INDESIT company

Model type:
LV670DUOIX

Commercial code:
F029948

n1045069: Modification of racks and dispenser lid on EVO3 dishwashers

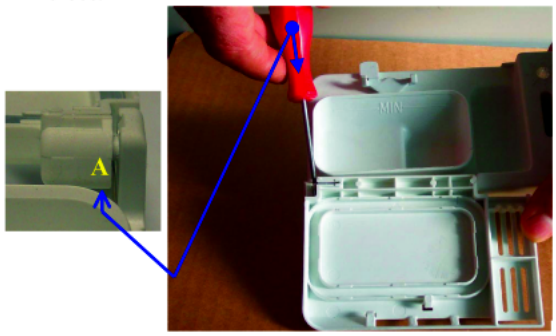
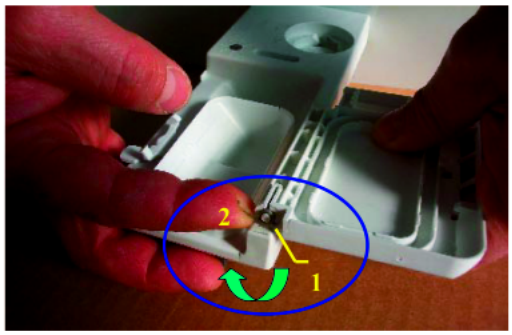
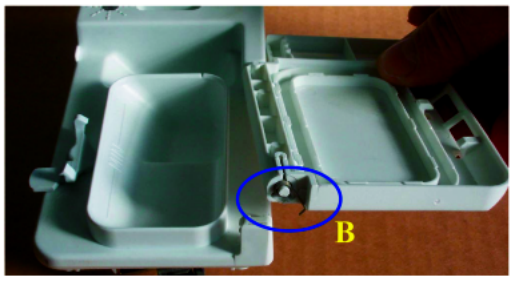
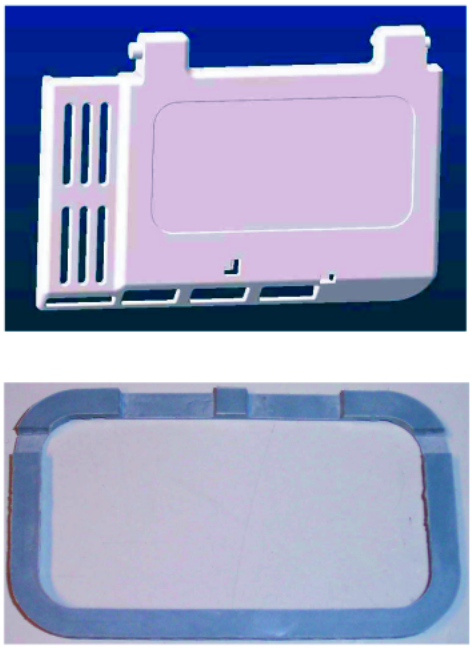
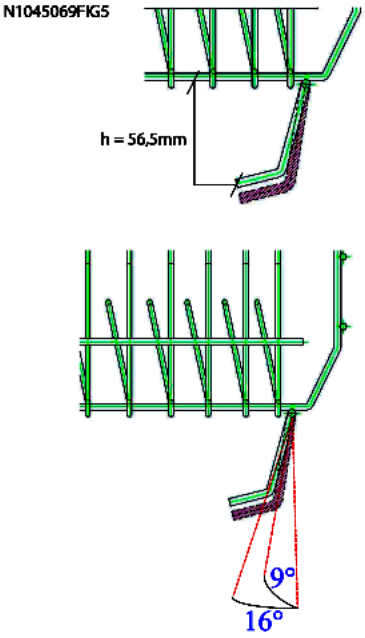
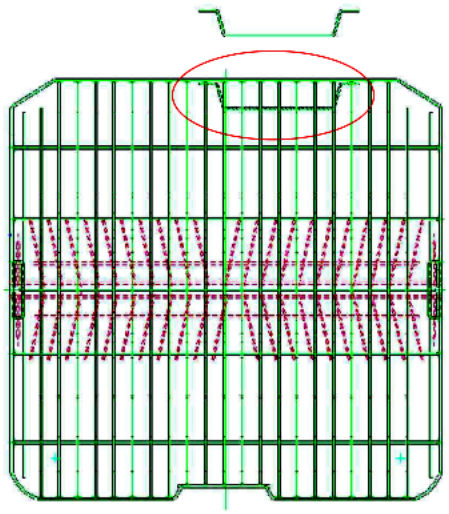
To obtain better dissolving of the detergent during the wash cycle, the following modifications have been made to EVO3 dishwashers:
- new dispenser lid, replacement code 098134 (see figure N1045069FIG4) created;
- upper racks modified with lid catch angle changed from 9° to 16° (see figure N1045069FIG5);
- MultiSystem lower racks modified with insertion of a spacer wire at the electric dispenser (see figure N1045069FIG6).

Lid installation instructions:
1) prise the lid out of the dispenser seat using a small screwdriver at point A (figure N1045069FIG1);
2) replace the lid, checking that release spring B (figure N1045069FIG2) is in place; before fitting the new lid load the spring from position 1 to position 2 (figure N1045069FIG2);
3) fit the lid in its special seat and check for correct operation (figure N1045069FIG3).
Lid closing may be harder for the first few cycles after replacement, due to settling of the material.

The upper and lower racks have the same spare part codes as the premodification items; Replacements Warehouse stocks have been replaced.

N1045083FIG1

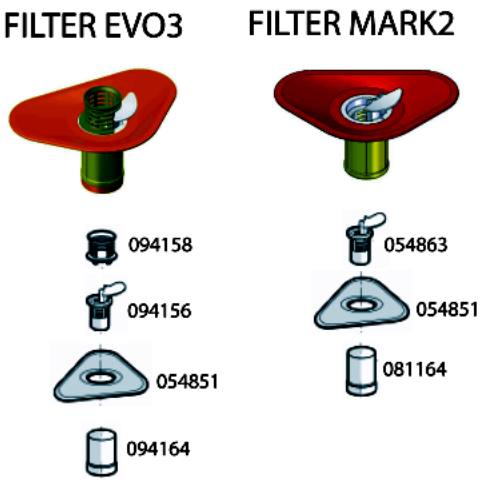
All dishwasher models affected by this modification have been equipped with the items listed below, in order to solve the drain pump clooging problem.

Introduction of:
Cylindrical plastic filter code 081164
Central filter code 054863

Elimination of:
Cylindrical plastic filter code 094164
Central filter code 094156
Central filter grid code 094158

The modification has been introduced progressively, starting from serial no. 40516.0001.

n1045085: Introduction of new litre counter turbine integrated on air-break.

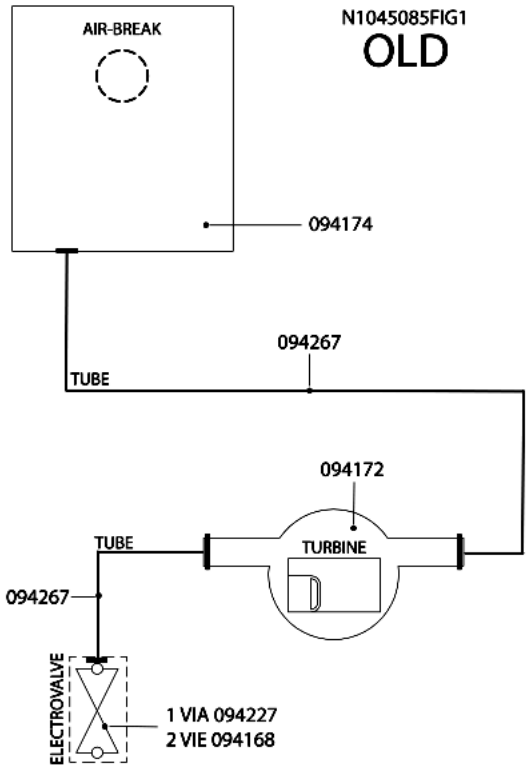
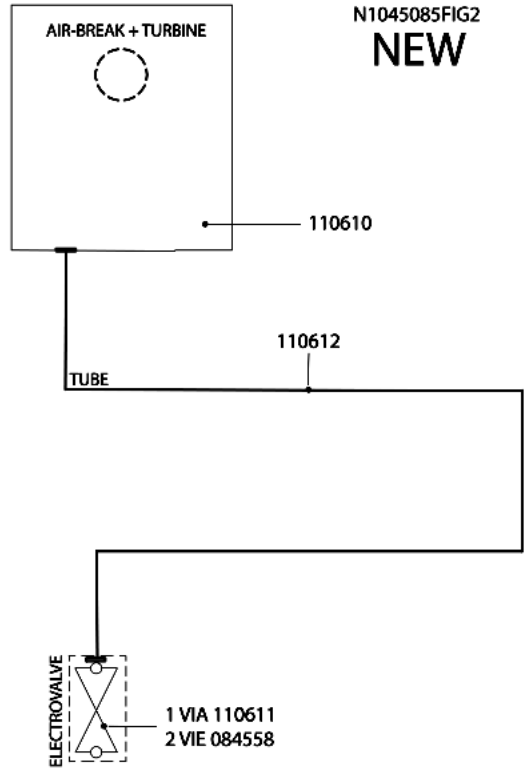
All dishwashers affected by this note have been equipped with a new litre counter turbine on the air-break.
Picture N1045085FIG1 illustrates the premodification structure, picture N1045085FIG2 the new structure.

AIR-BREAK:
new 110610;
premodification 094174;
the new item features a new integrated litre counter turbine and its water supply hose has a smaller diameter.

LITRE COUNTER TURBINE code 094172 has been eliminated.

SOLENOID VALVES:
new:
1-WAY code 110611;
2-WAY code 084558(Rohs 143737);
premodification:
1-WAY code 094227;
2-WAY code 094168;
the new solenoid valves have a smaller diameter drain hose fitting.

HOSES:
new solenoid valve hose/air-break code 110612;
premodification turbine hose/air-break code 094267;
premodification solenoid valve hose/air-break code 094267;
the new hose has a smaller internal diameter.

WIRING:
the litre counter turbine connecting cable is longer, but since the connector is the same, the new item can be used in place of the premodification one.

N1045093FIG1
NEW FLAP UPPER BASKET SAT CODE 114799

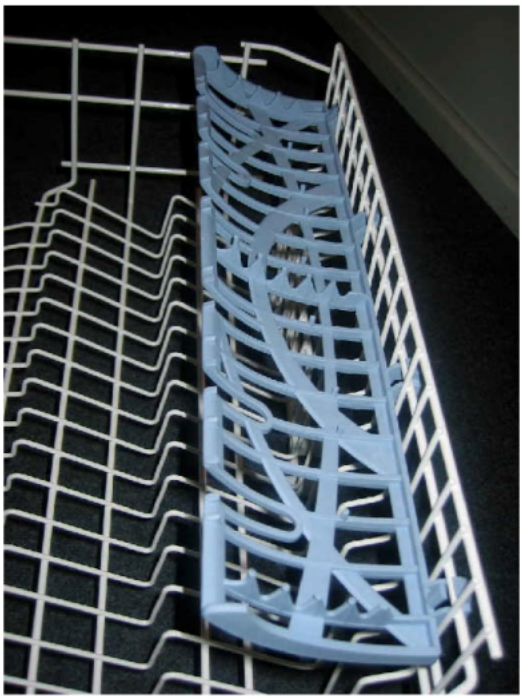
From serial no. 41109.0001 all models affected by this bulletin feature a modification of the folding shelf to upper basket coupling system.

This modification called for alteration of the relative baskets: the distance between the wire on which the folding shelf is attached and the wire below it has been increased from 9.5 mm to 17 mm, as shown in the attached image.
The altered folding shelves are not interchangeable and cannot be installed on premodification baskets: in the case of service interventions on product with serial number prior to 41109.0001 the entire upper basket must be replaced.
The baskets are reciprocally interchangeable and are managed as assemblies complete with their accessories, inclusive of folding shelves.

UPPER BASKET LIGHT BLUE FOLDING SHELF
new 114799 - premodification 094140.

UPPER BASKET ASSEMBLIES
new 115001 - premodification 094139;
new 115002 - premodification 094222;
new 115003 - premodification 094233.
